HISTORIC DISTRICT COMMISSION  
STAFF REPORT

5:30 pm • June 24, 2019 • City Hall

# AGENDA

Applicant provided north elevation

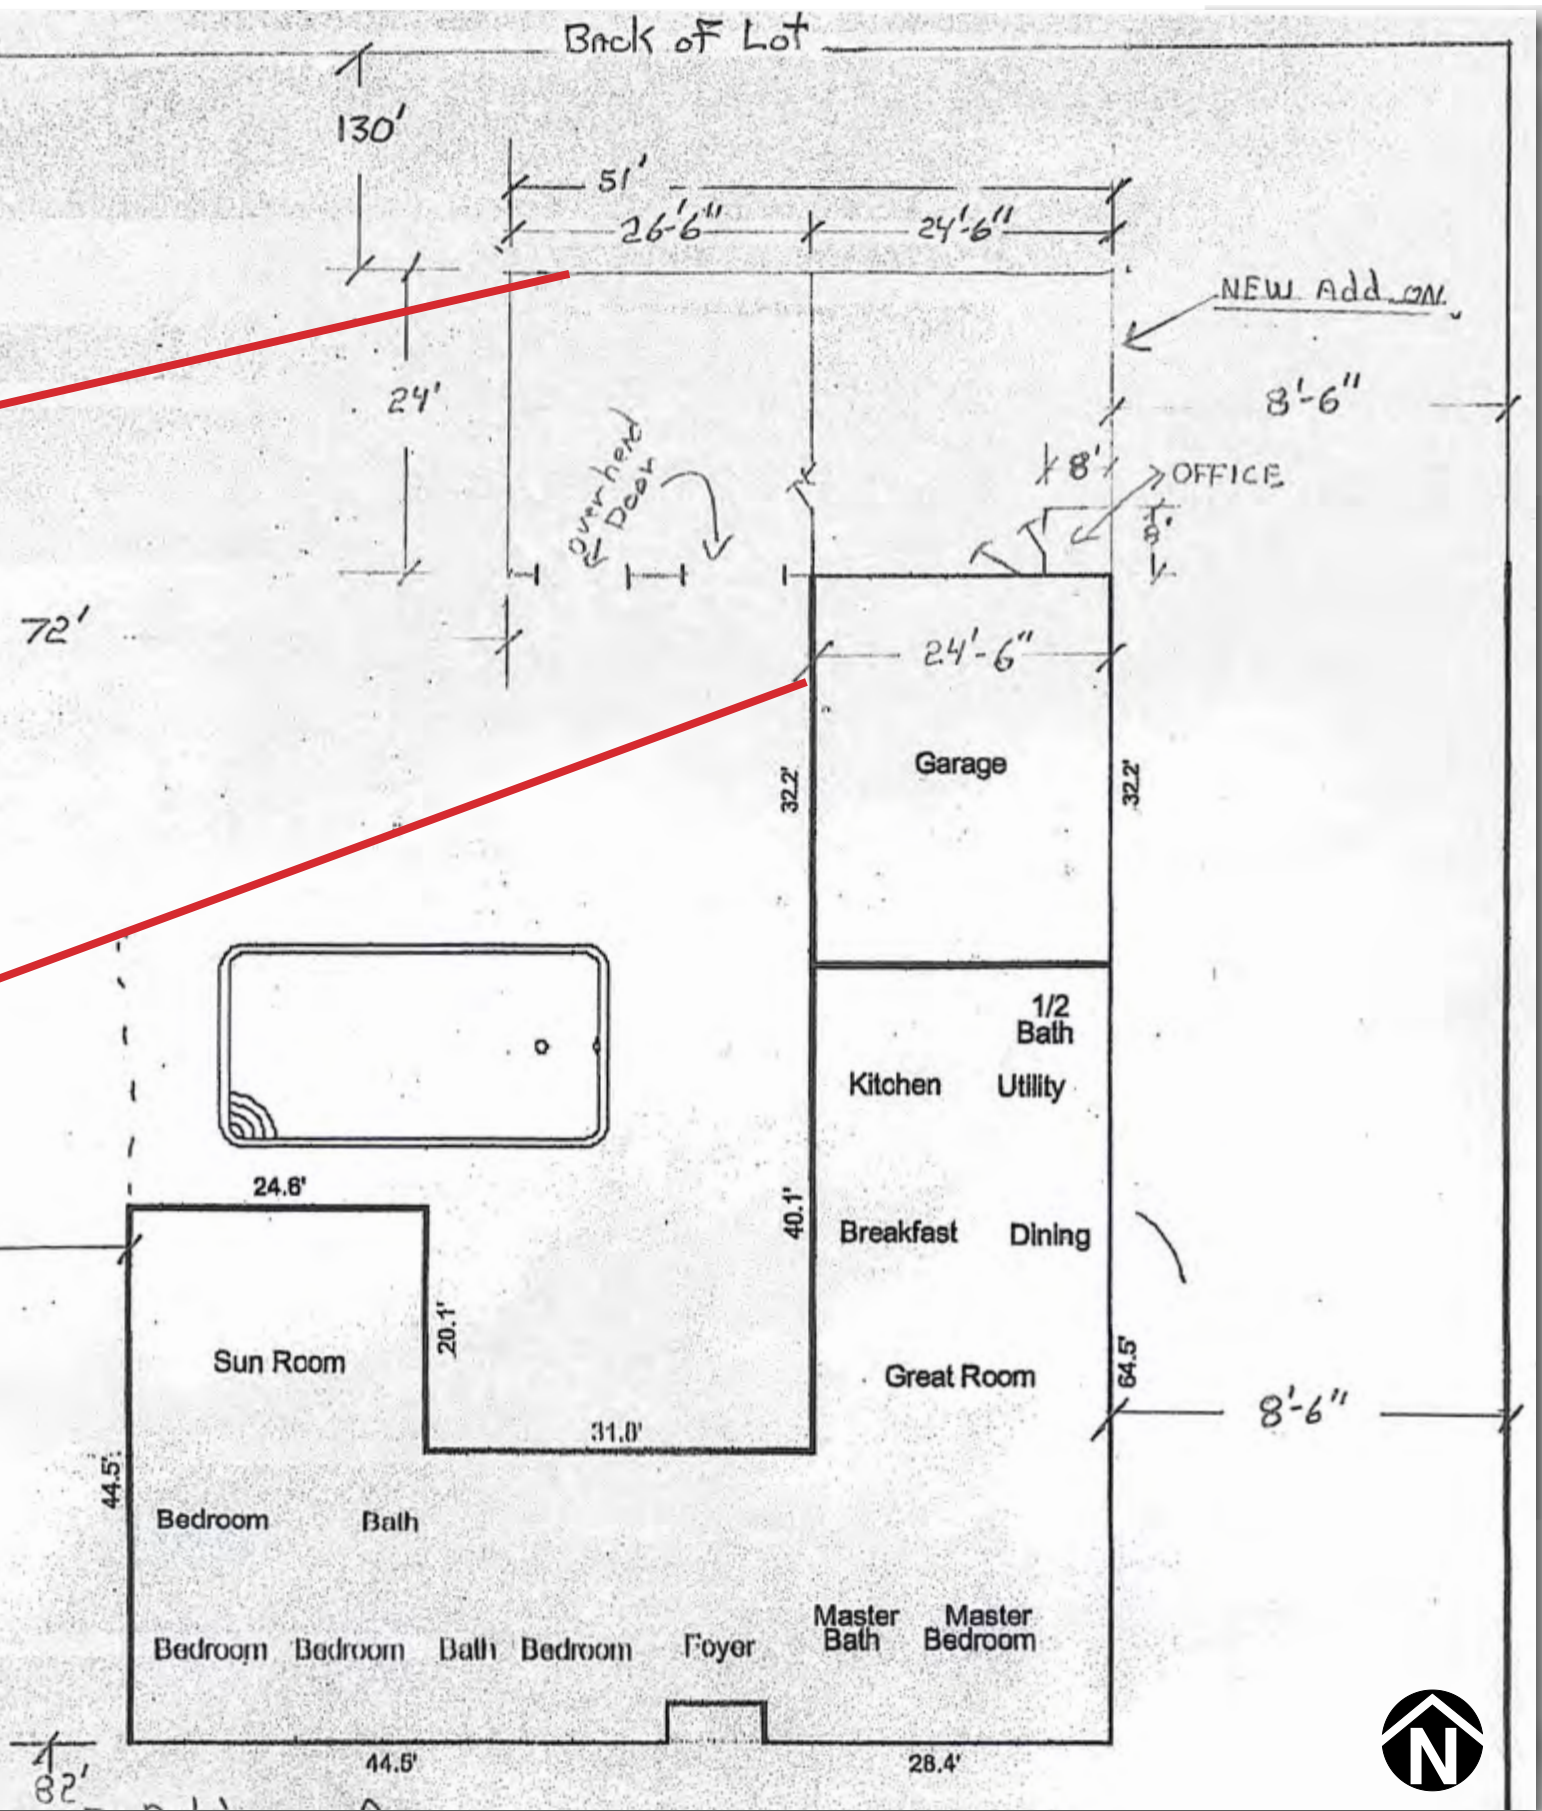
*Detailing and materials are uncertain from the application. The applicant included a detail of T1-11 plywood to be used to match the existing siding on the house where the addition is to be completed. Staff recommends minimum requirements be imposed as a condition of approval. This would include requirements for the use of wood or Hardie board.*

1. The addition shall be constructed with wood or Hardie board, as appropriate.
2. HVAC equipment be placed in a manner to minimize its visibility from the street.

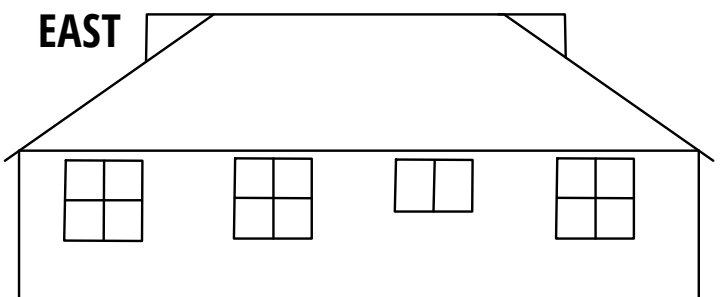
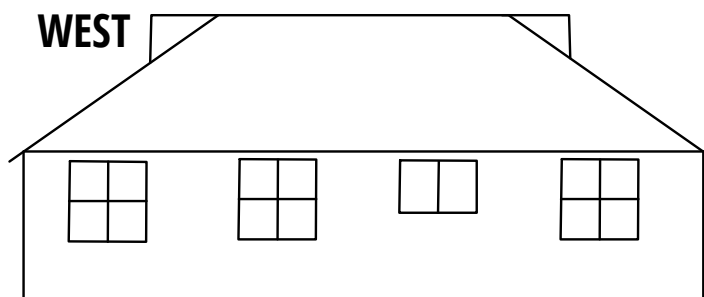
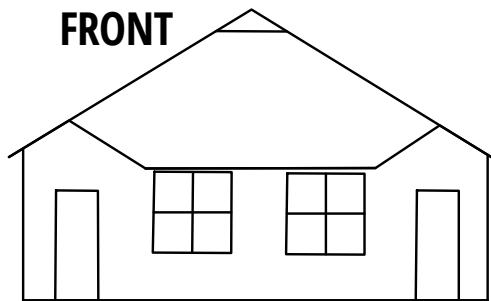
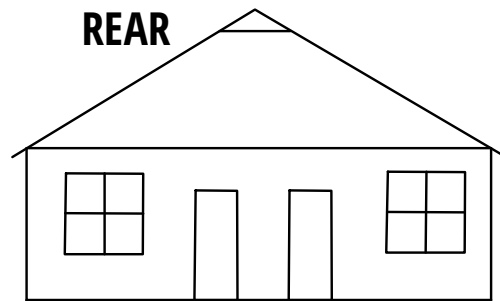
*Four windows will be added. While elevations have been provided, no specific detailing on the windows to be used or the size of the windows openings have been provided except that the windows shall be one over one panes. Recommend requiring wood windows of a size to match the existing openings. The existing windows are highly distinctive and should not be replaced.*

*The applicant will use matching brick on the addition. Recommend alternatively allowing wood or Hardie Board to allow distinction between the addition and the original structure. Recommend requiring open eave construction to remain consistent with the remainder of the home.*

1. The addition may be constructed with brick, wood or Hardie board, as appropriate.
2. HVAC equipment be placed in a manner to minimize its visibility from the street.
3. The new windows shall match the existing window openings on the structure and be wood windows.
4. The roof addition will use open eave construction.
5. The applicant will provide revised plans for the windows and proposed materials to the Planning Director for review and approval prior to issuance of building permits.

**EXISTING**

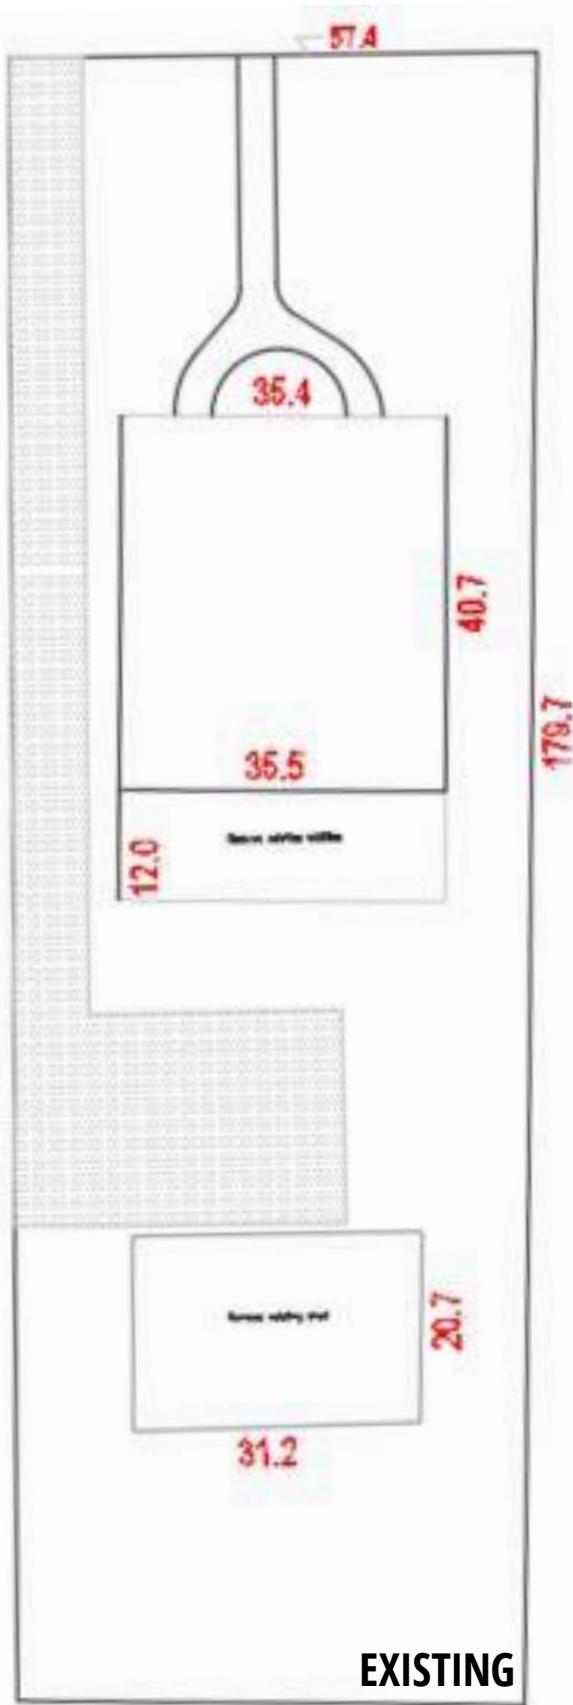
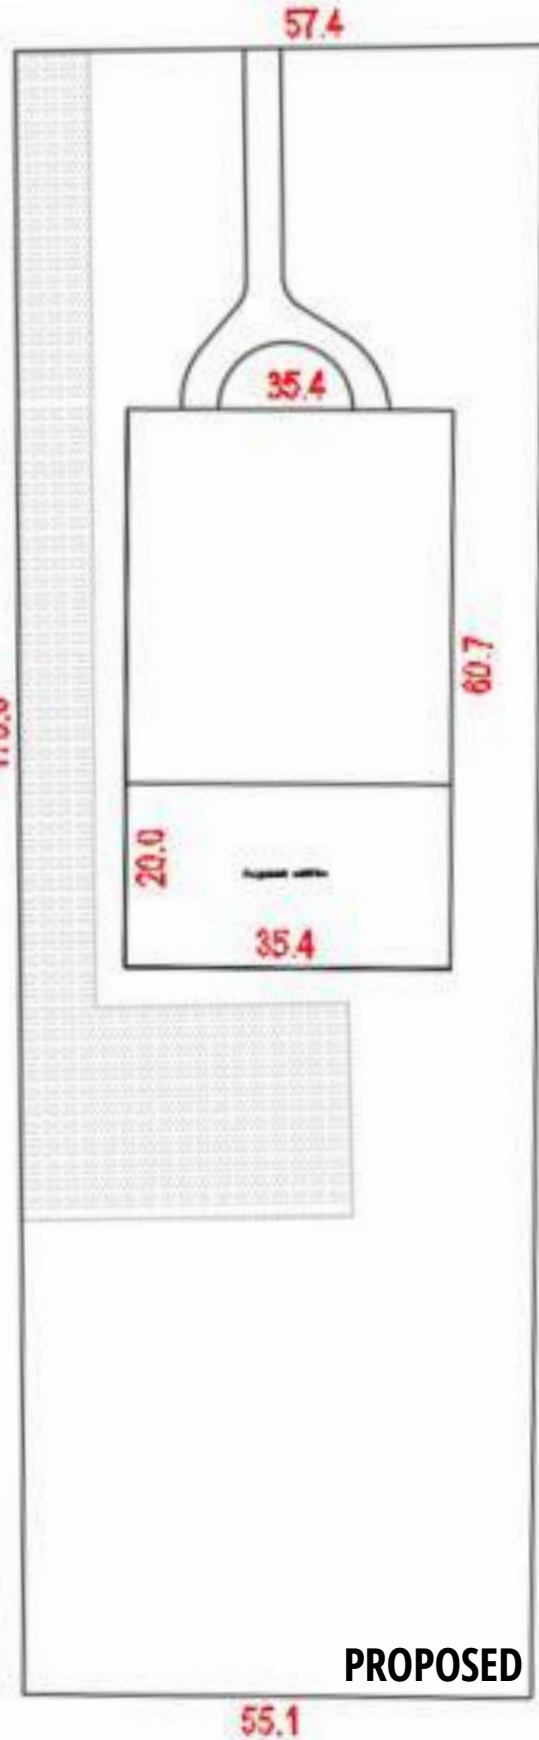
**Development.** The existing structure is a 1,280 sf minimal traditional duplex, originally constructed in 1942, with a later addition. The structure has original windows and small lean-to accessory structure at the rear of the property. The applicant is proposing to remove the existing 12' x 35' addition and the existing lean-to accessory building to construct a 20' x 35' (700 sf) addition to the rear of the structure to allow the duplex to be converted to two 2-bedroom units.

**Setbacks and Spacing.** The structure will main the same side setbacks with 9.5' to the east and 12' feet to the west. The rear setback will be reduced to 79' from 87' feet.
